MEMORANDUM

SUBJECT: Site Plan Approval – VL Main Avenue, 144 Main Avenue, 160 Main Avenue, 160 Rear Main Avenue, 164 Main Avenue and 202 Main Avenue, Parcel Numbers 2-01-332.002, 2-01-301.001, 2-01-301.000, 2-01-302.000, 2-01-332.003 and 2-01-332.004

DATE: July 27, 2023

Request: Site Plan Approval to construct a 15,900 SF, 61-unit, four-story apartment building at **VL Main Avenue, 144 Main Avenue, 160 Main Avenue, 160 Rear Main Avenue, 164 Main Avenue and 202 Main Avenue**, Parcel Numbers 2-01-332.002, 2-01-301.001, 2-01-301.000, 2-01-302.000, 2-01-332.003 and 2-01-332.004

1 LANDSCAPING PLAN
L101 SCALE: 1" = 20'

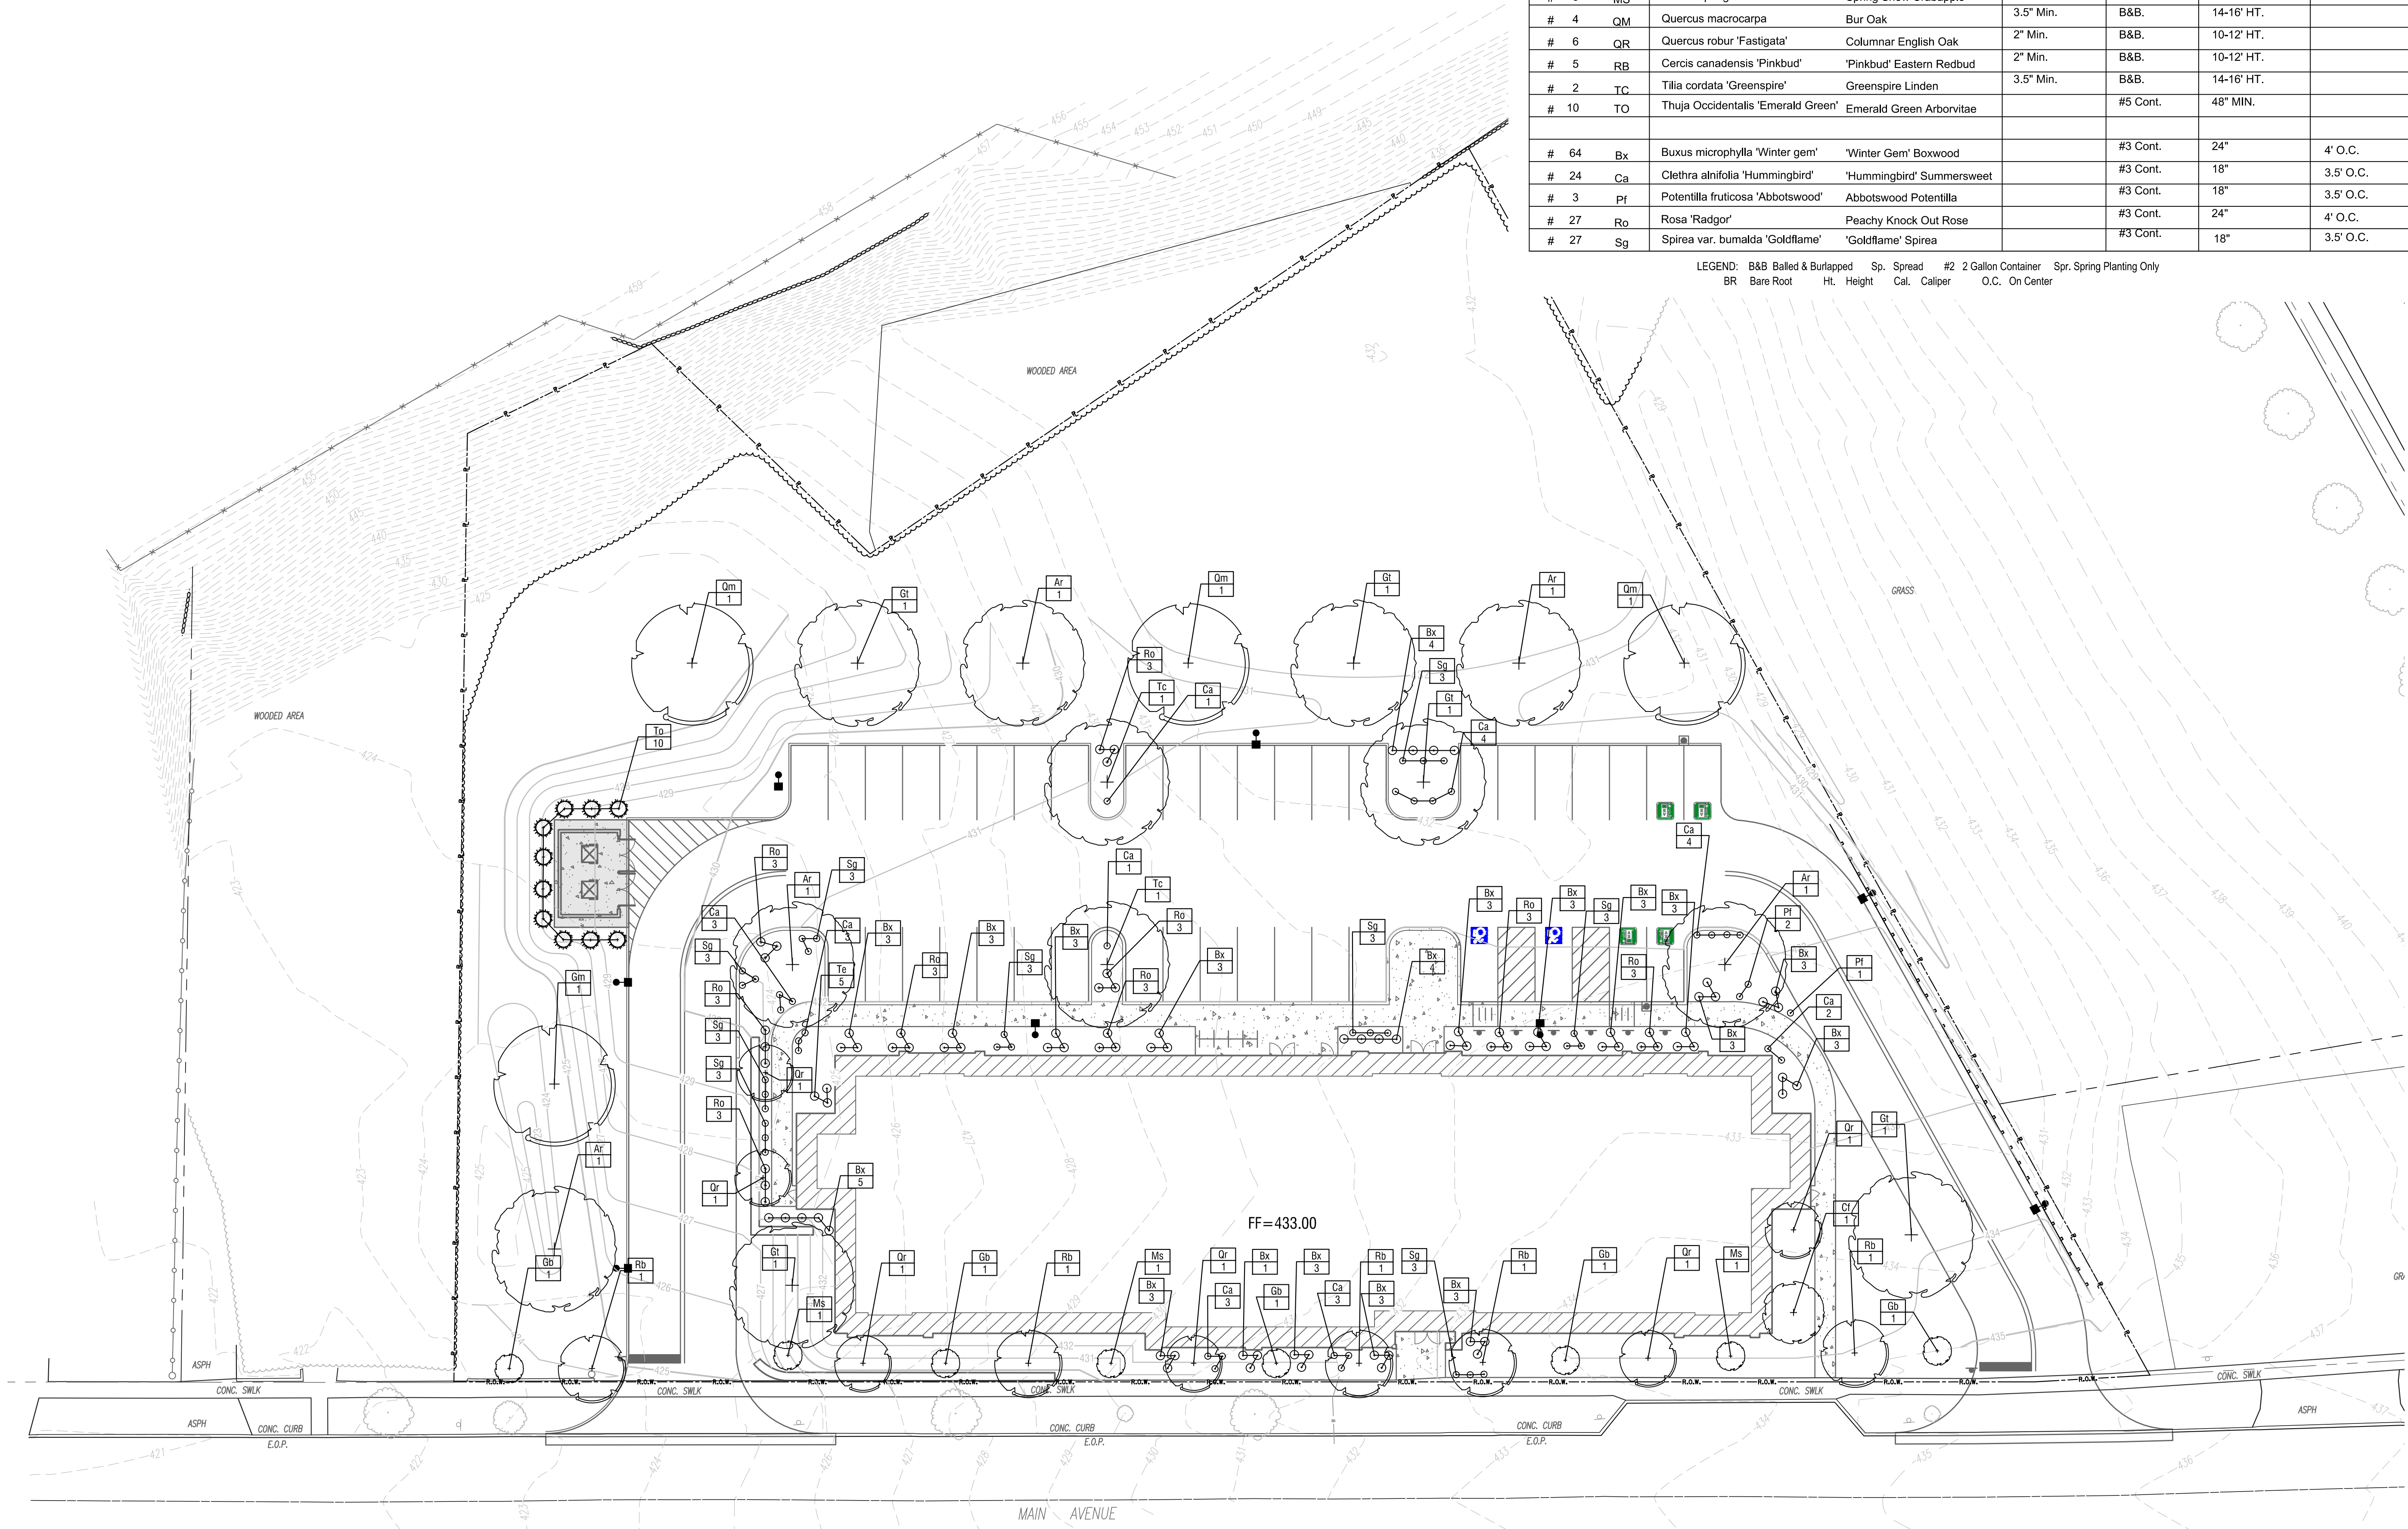
Miscellaneous: The Site Plan designates two snow storage areas along the north side of the parking lot. The landscaping plan shows trees proposed for this area. Snow removal operations could negatively impact the trees in this area. Per City Code, the applicant will be responsible for maintaining and replacing trees required for site plan approval. To avoid future damage to the trees, the applicant should amend the planting plan to relocate trees from the proposed snow storage areas.
